ADDENDUM NO: 03

DATE: 08 April 2025

PROJECT NO: 119.002

PROJECT: Hyde Park Elementary School
333 East 300 North
Hyde Park, Utah 84318

A1 AS101 **SITE PLAN**
1" = 30'-0"

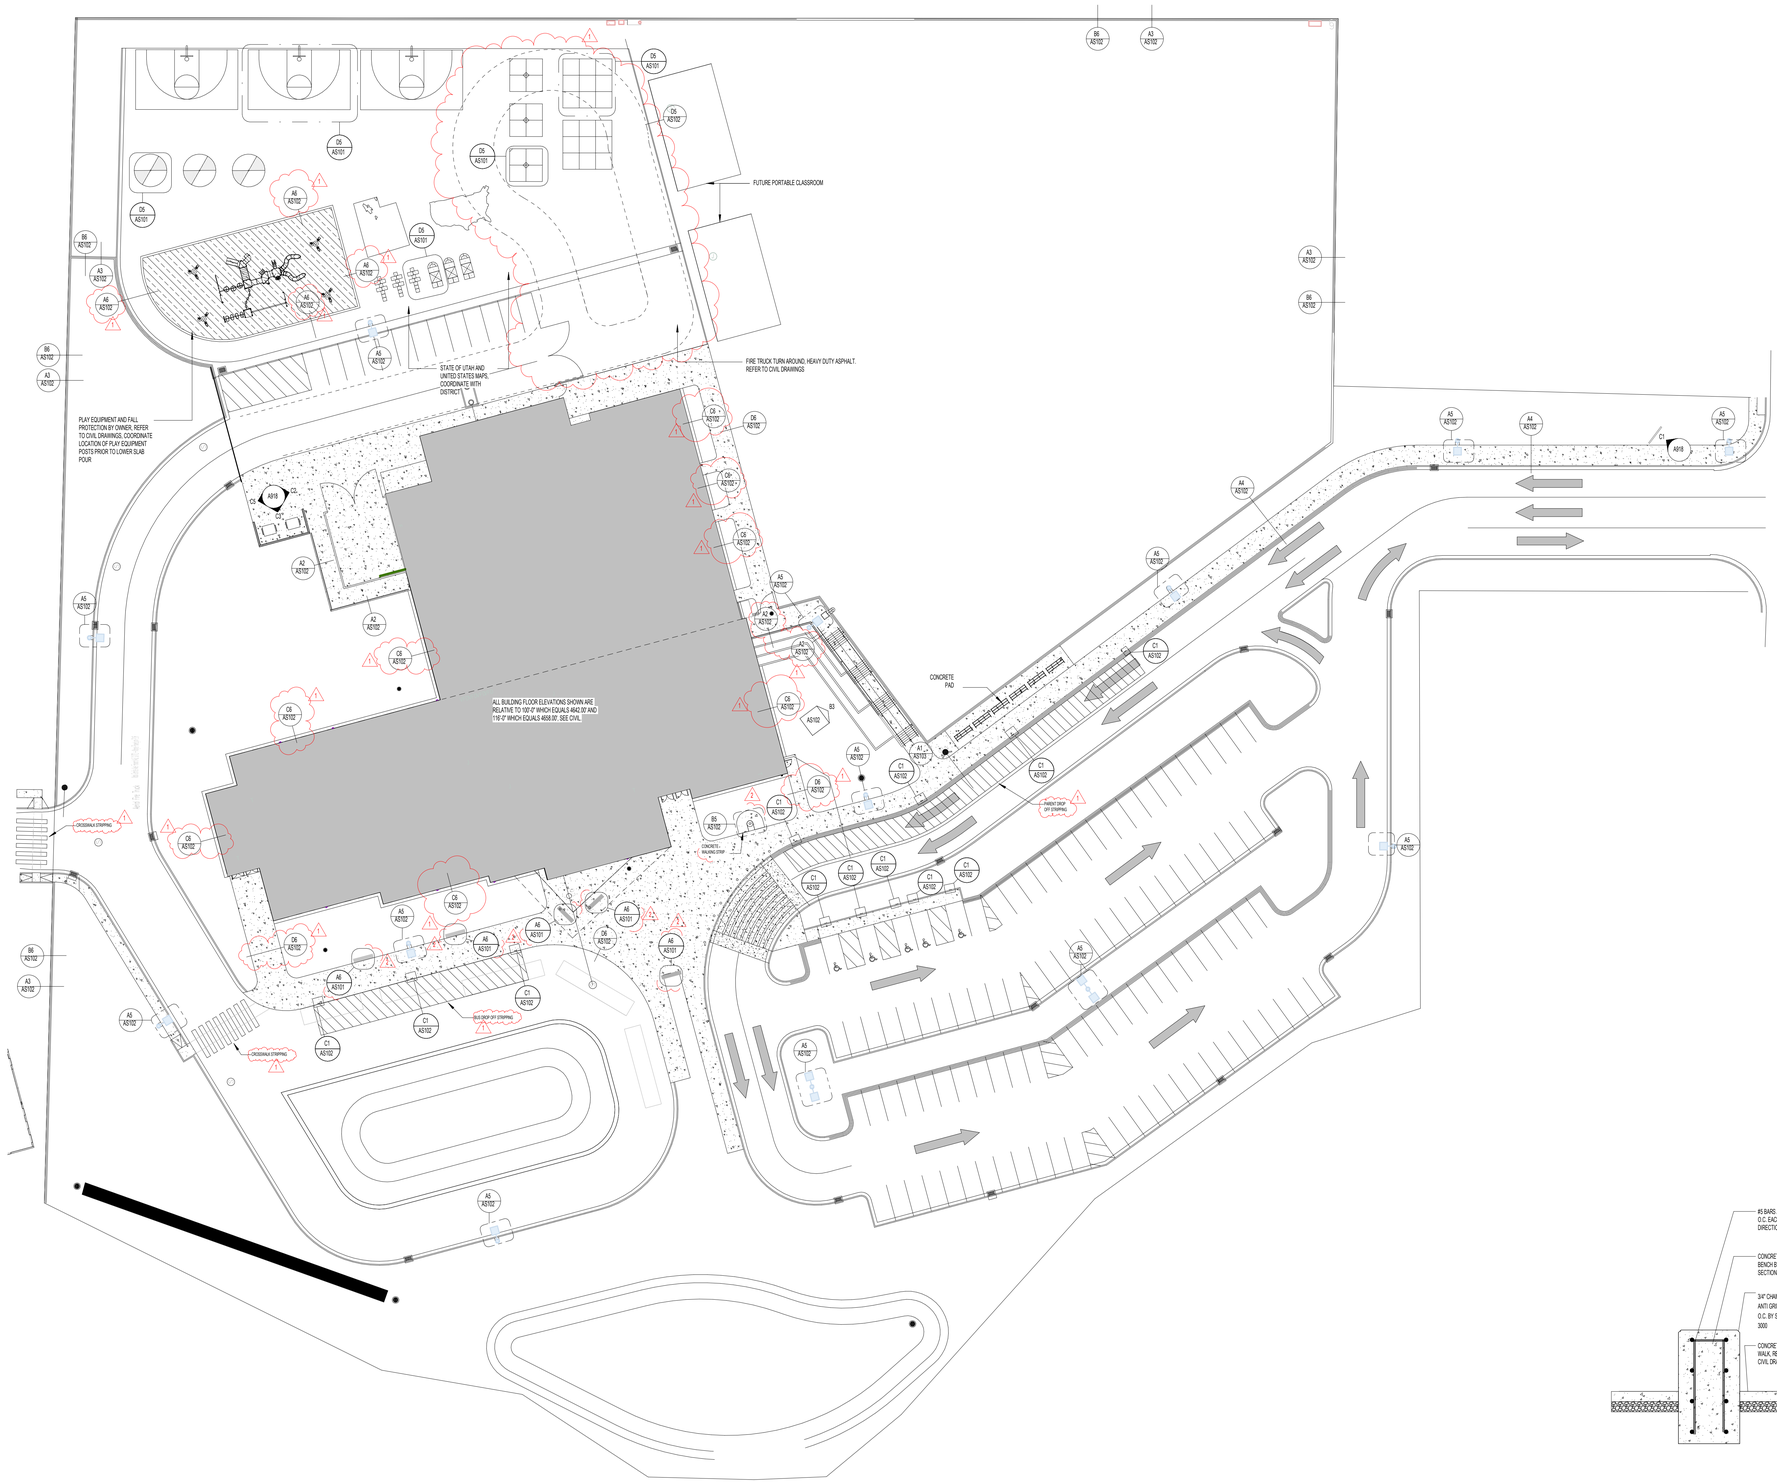
- **Detail A6/ AS101 updated to show where structural column location in concrete benches.**
- **Site concrete bench locations marked on site plan.**
- **Concrete walking strip placed around flag pole.**

A2 AREA B1 REFERENCE FLOOR PLAN
1/8" = 1'-0"

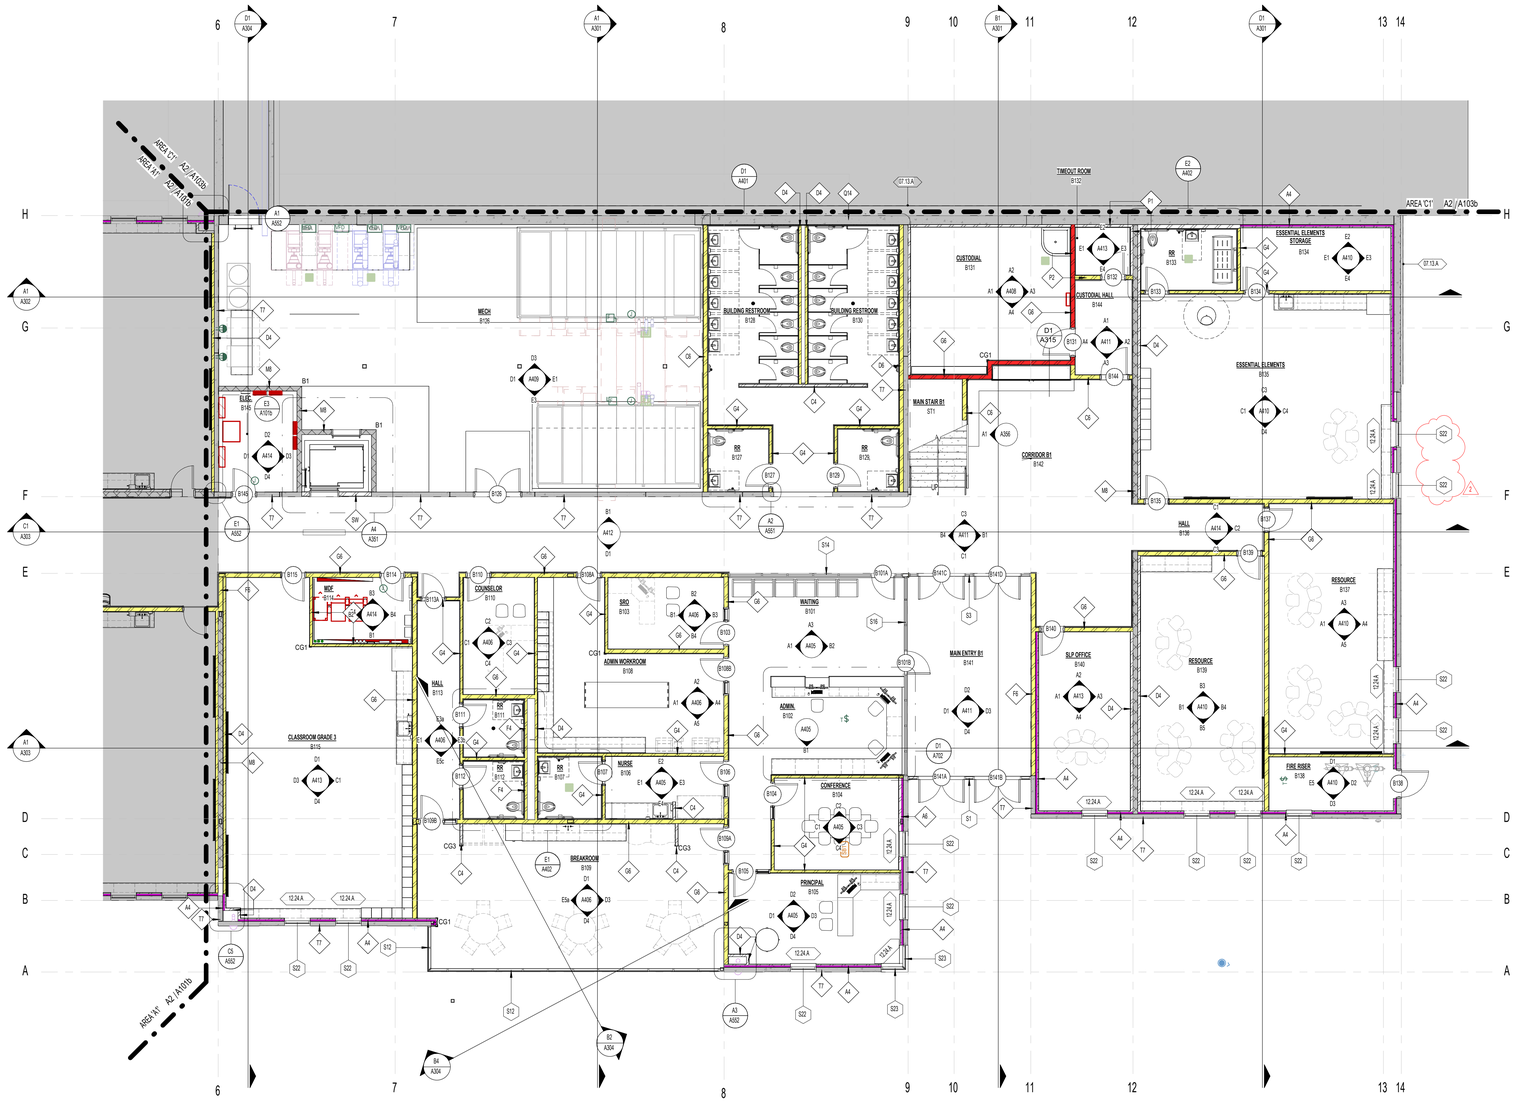
- **Window tags added to plan view at RESOURCE CLASSROOM.**

1 LEVEL B2 DIMENSION FLOOR PLAN
A106a 1/8" = 1'-0"

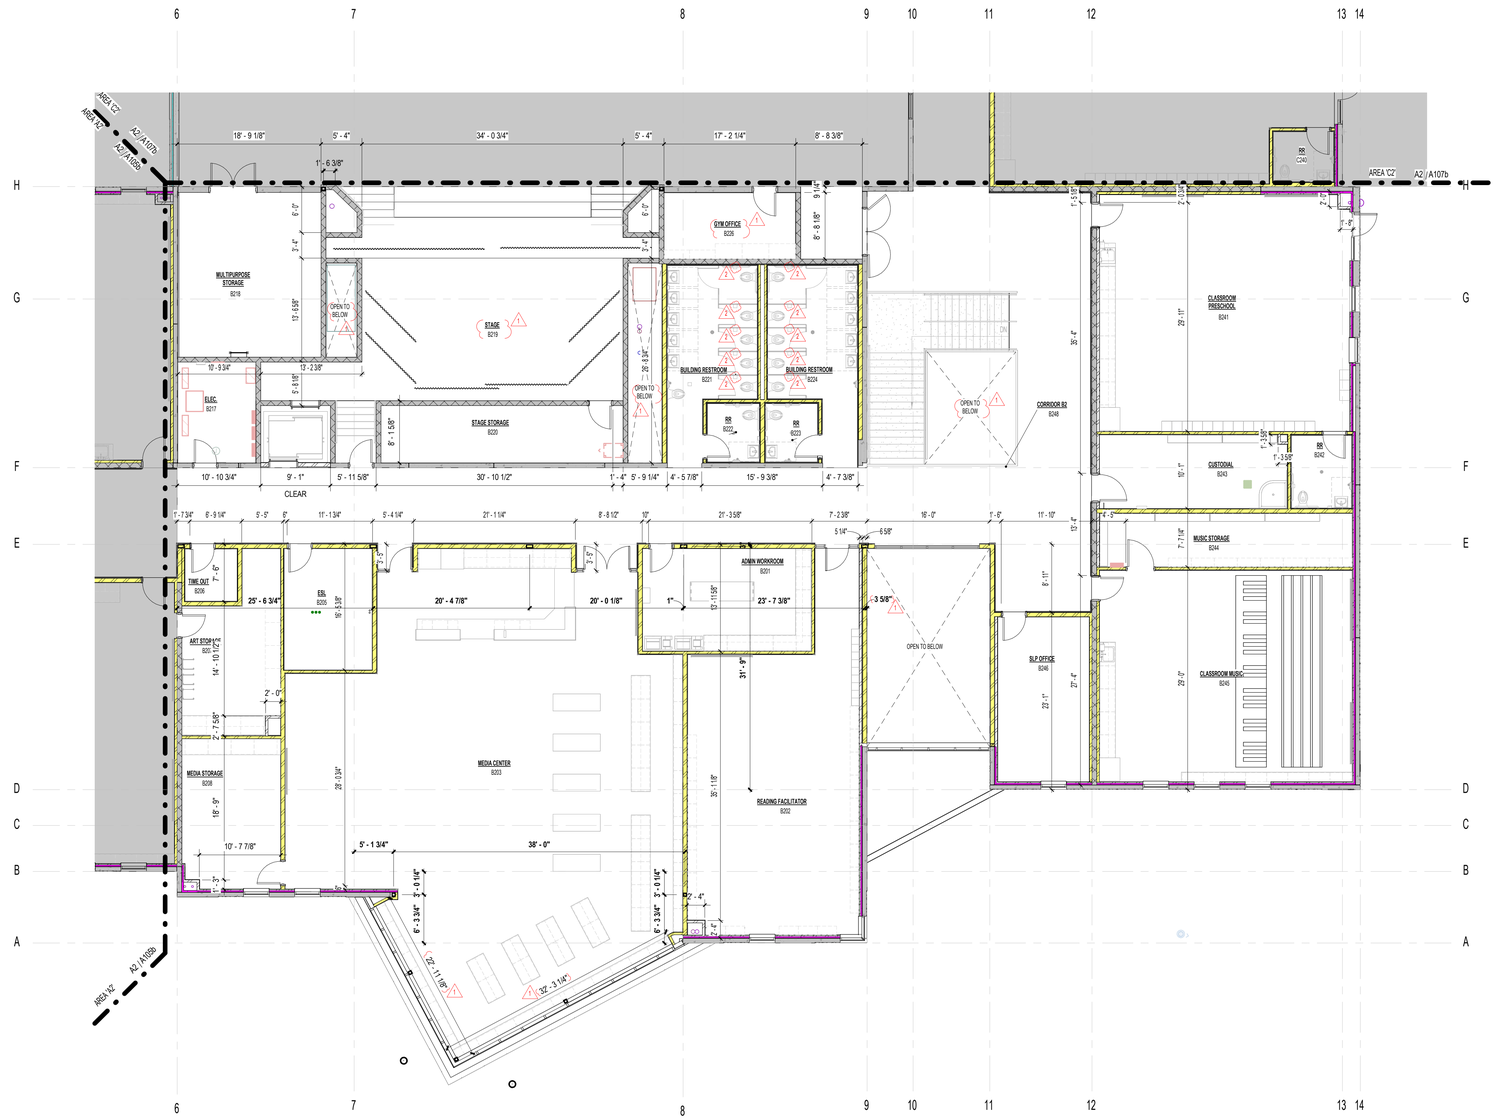
- **Toilet paper holders have been added to bathroom B221 and B224**

A2 / A106b AREA B2 REFERENCE FLOOR PLAN
1/8" = 1'-0"

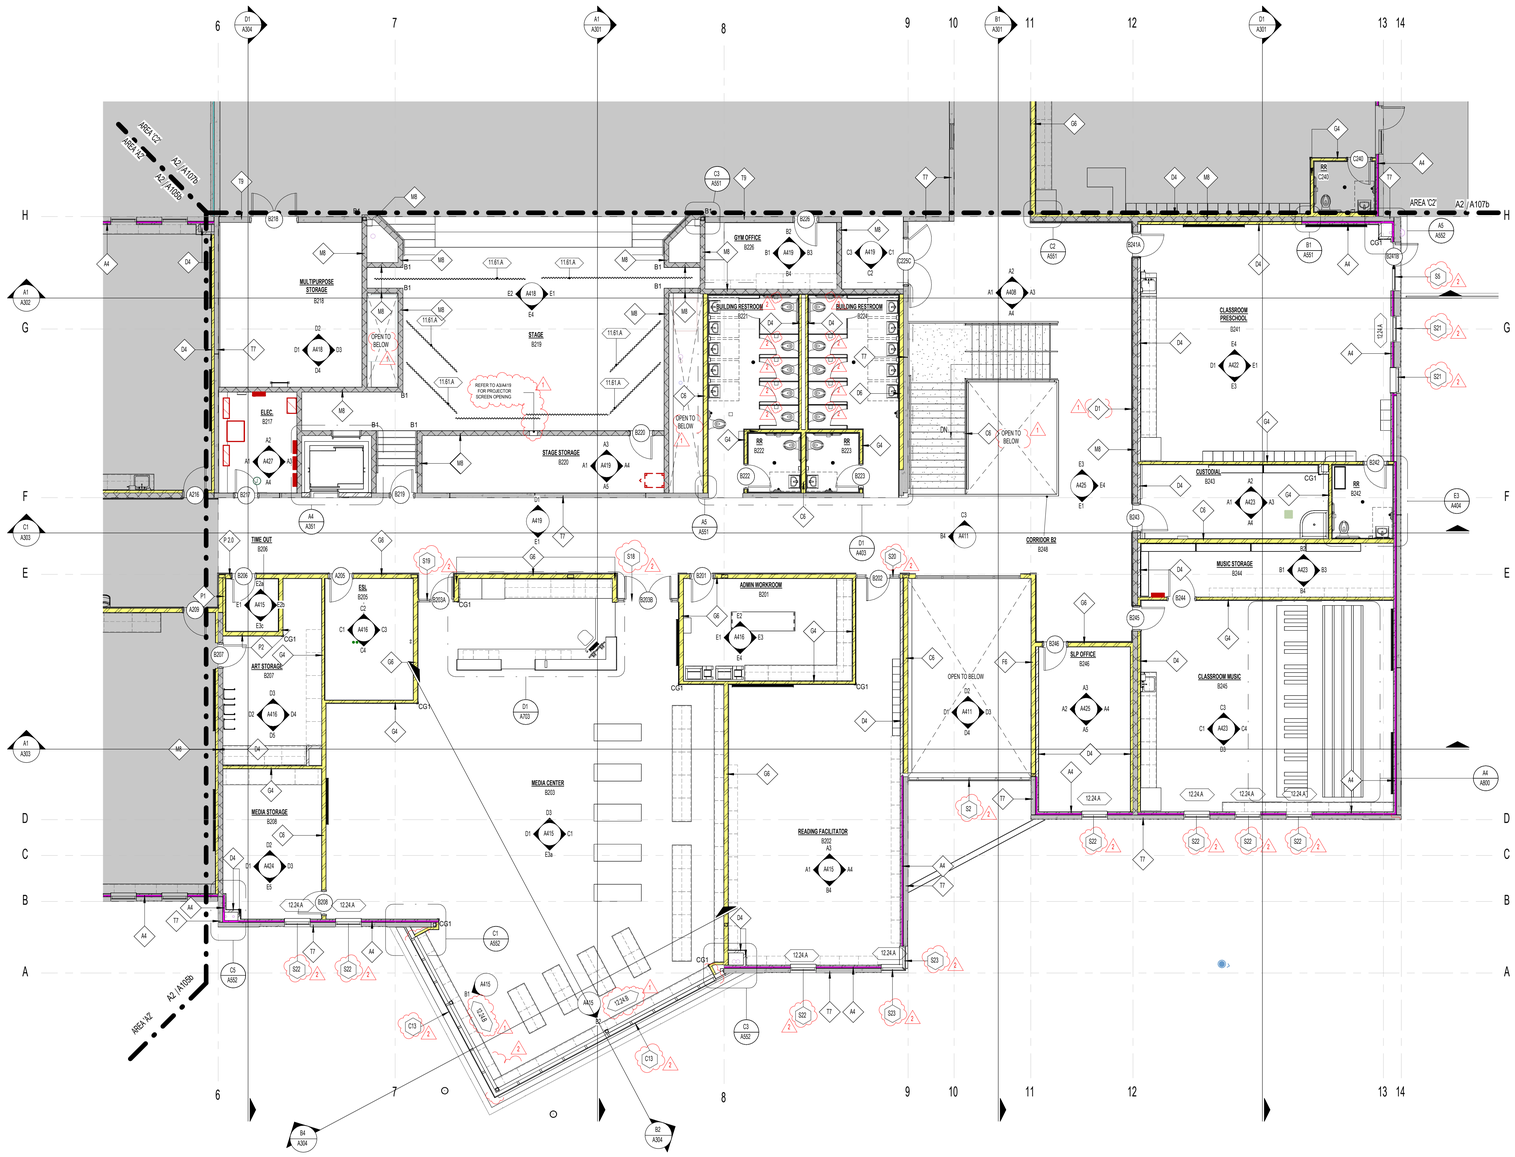
- **Adjusted MEDIA CENTER vertical mullions in system to correctly align with structural and interior elements on elevations.**
- **Toilet paper holders have been added to bathroom B221 and B224**
- **Window tags added to all windows on plan**

1 AREA B2 FINISH FLOOR PLAN
A106c 1/8" = 1'-0"

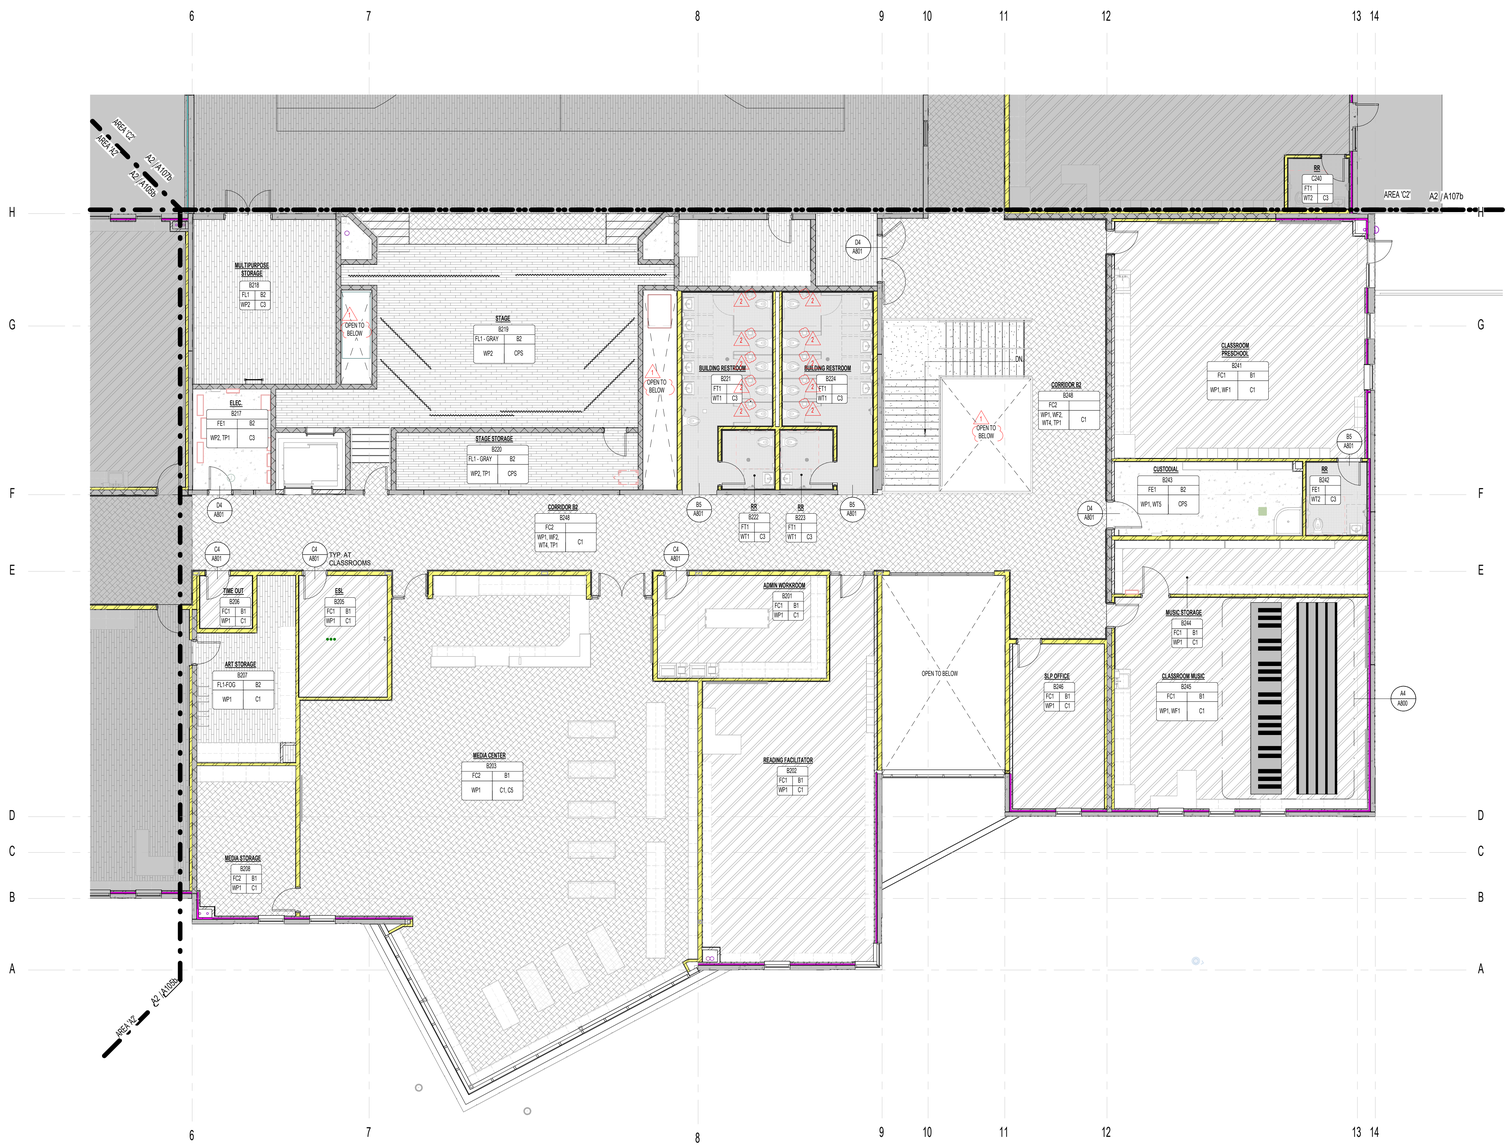
- **Toilet paper holders have been added to bathroom B221 and B224**
